Memorandum

On Clearwire Coverage Issues

To Acton Planning Board
From David Maxson
Re Clearwire Coverage Issues

4 May 2010

Clearwire Coverage from Wireless Facility Sites in and around Acton

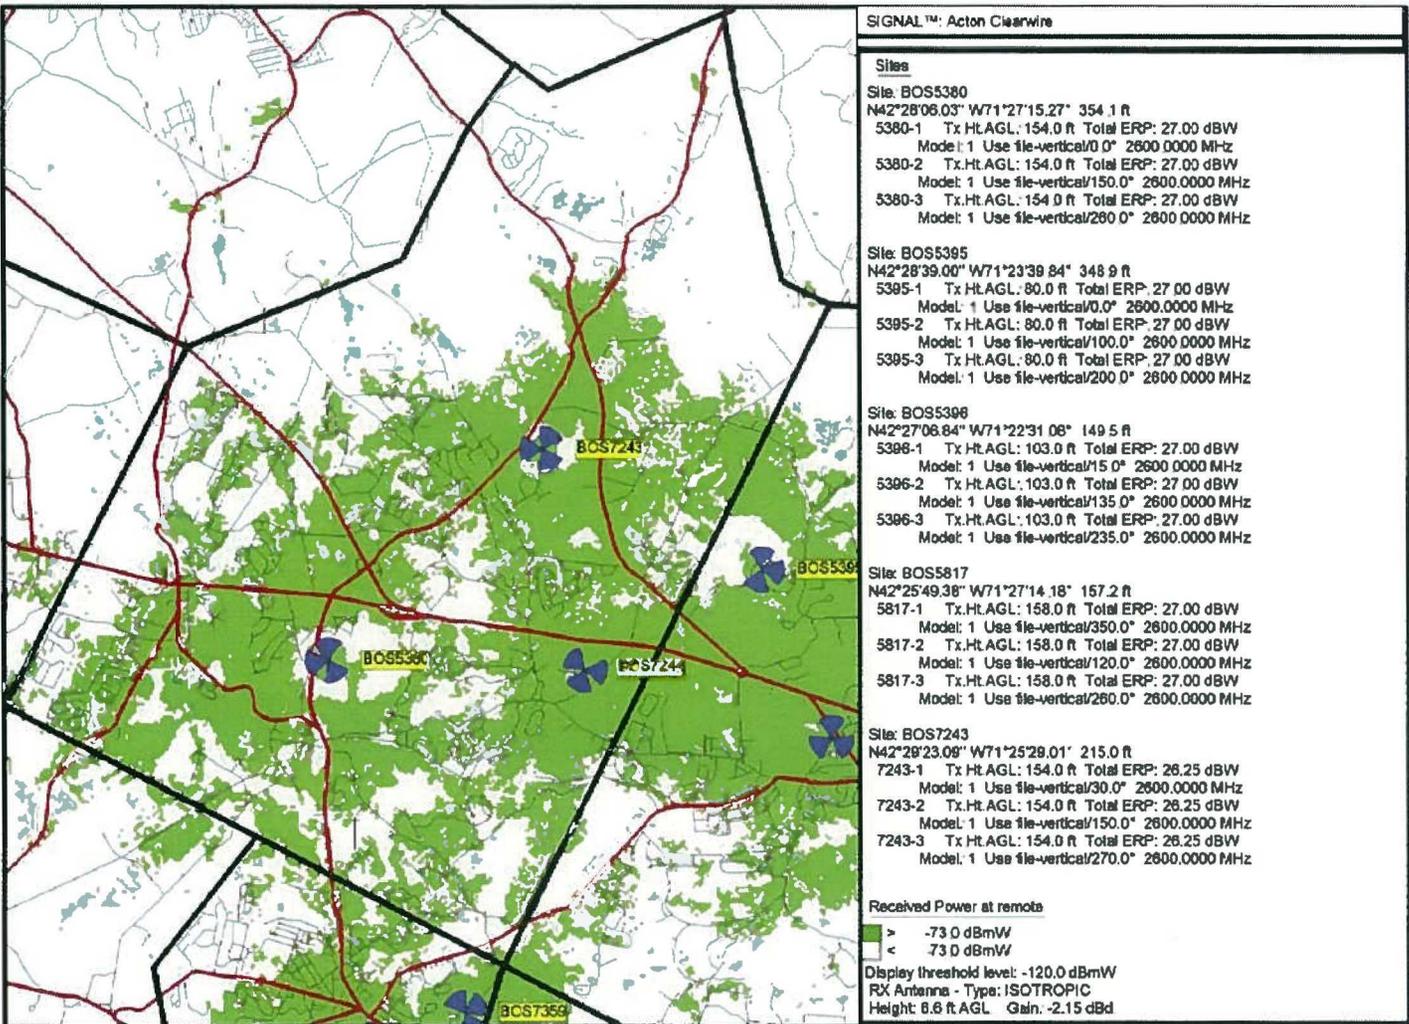
Broadcast Signal Lab, lacking any rationale for the chosen signal level, modeled the Clearwire facilities, existing and proposed, at -80 dBm (a lower signal level) based on the premise that this is a generous signal level for modeling typical wireless communications. Our analysis, submitted in our April 30 report, prompted Clearwire to provide Broadcast Signal Lab with some of the details we needed.

Clearwire states that the baseline signal level (called receiver sensitivity) for WiMAX receivers is -89 dBm. This means that these WiMAX devices are significantly less sensitive than traditional wireless devices on GSM or CDMA technology, which tend to work at signal levels as low as -105 to -113 dBm. Other “margins” are added to the baseline signal level to account for other factors that affect reliable operation. This kind of analysis is called a “link budget.” Based on the newly reported receiver sensitivity and link budget assumptions provided by Clearwire, we have revised our signal level modeling from -80 dBm received signal strength to -73 dBm.

Direct Link Line of Sight from Emerson Hospital at 110 ft AGL to Great Hill 150 ft AGL

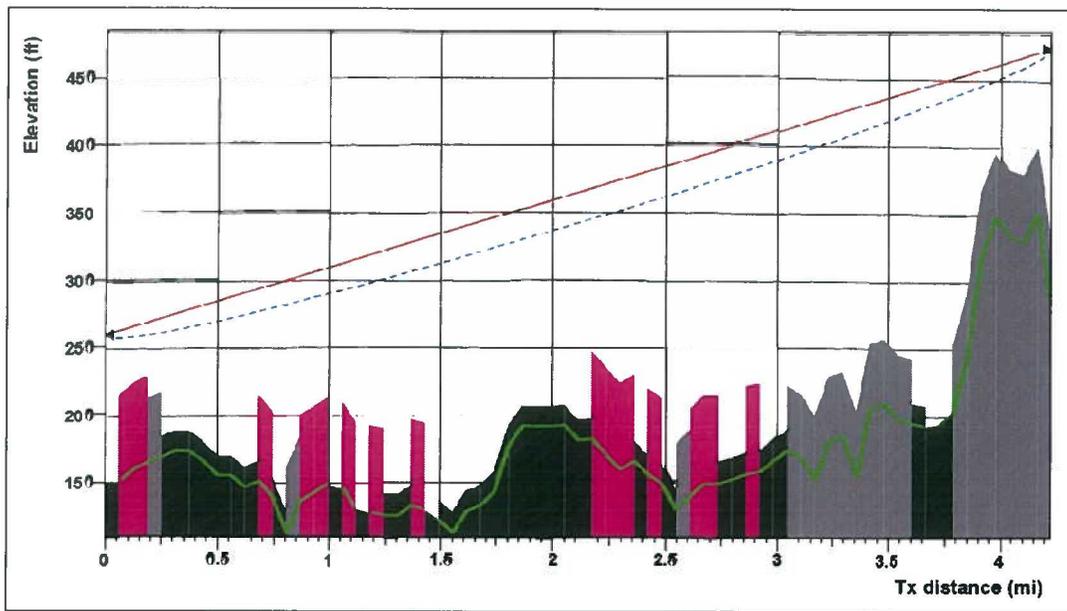
We suggest that it is not necessary to back haul between the proposed Site and Emerson Hospital directly. Both the proposed Site and Emerson Hospital have a line of sight to the tower on Great Hill, as shown by the figures below. These figures are called “path analysis”. They show the height of the antennas at each end of the path (red line). They show the intervening terrain (green line). They also approximate the height of buildings and vegetation between the two ends of the path (black, gray, and pink vertical bars). The blue ellipse below the red line indicates a “fresnel zone”¹ around the signal path, which ideally should not intersect with terrain or vegetation.

Direct Link Line of Sight from Proposed Craig Road Site (90 ft AGL) to Great Hill (150 ft AGL)

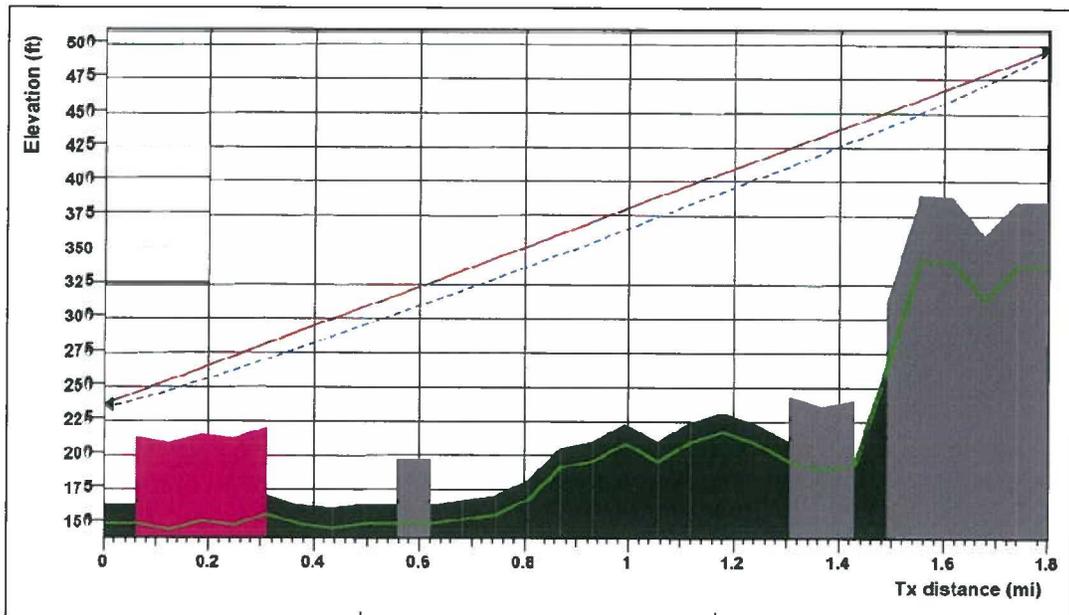
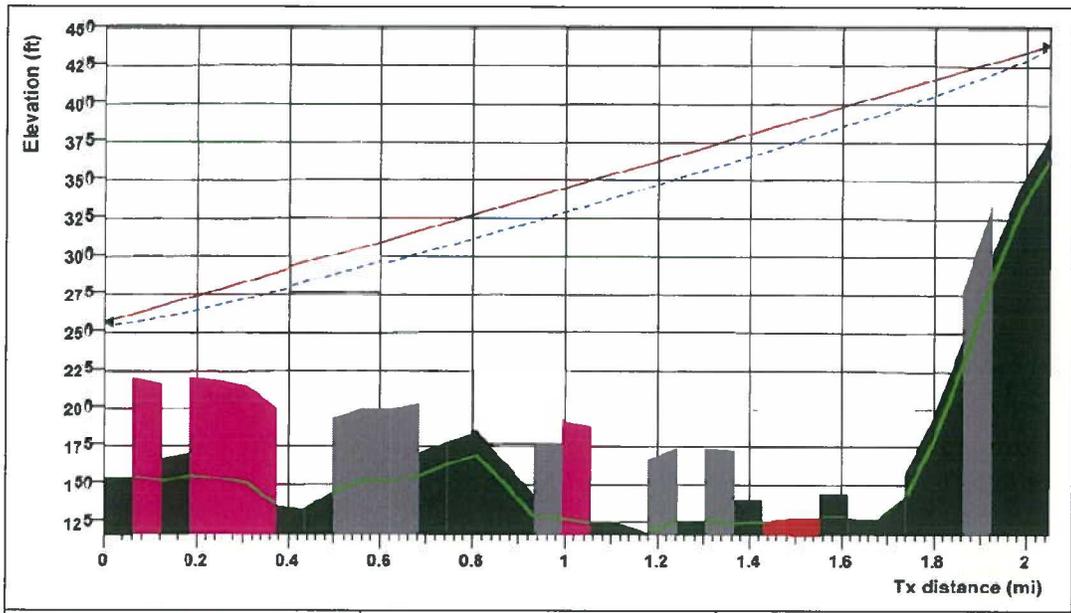
The line of sight path from the proposed Site to Great Hill is also clear.

The foregoing images illustrate that for a single-link-per-site design, there is no need to provide a direct link from Craig Road to Emerson Hospital, because both sites “see” Great Hill.

Link Line of Sight from Emerson Hospital to Annursnac Hill

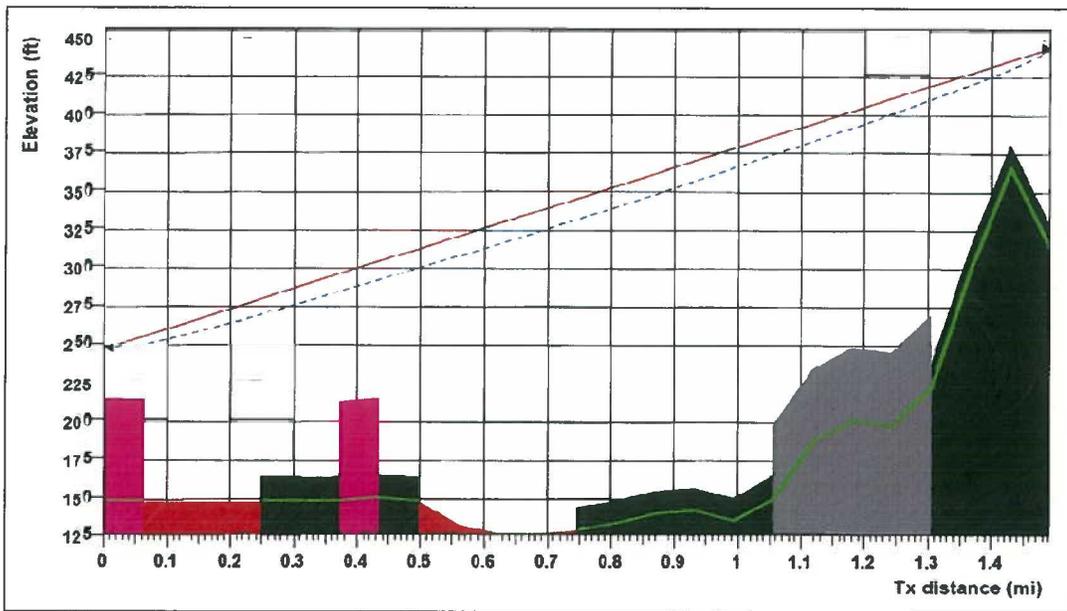
We suggest, *if it is highly desirable to maintain a lower tower height at Craig Road*, there may be a way to modify the ring to address Clearwire’s objectives. For instance, a facility at Annursnac Hill can “see” Emerson Hospital, Great Hill and Craig Road at 100 feet. If there is antenna space at Annursnac, there may well be a way to maintain redundancy of links without requiring the proposed Craig Road tower to be 140 feet tall.
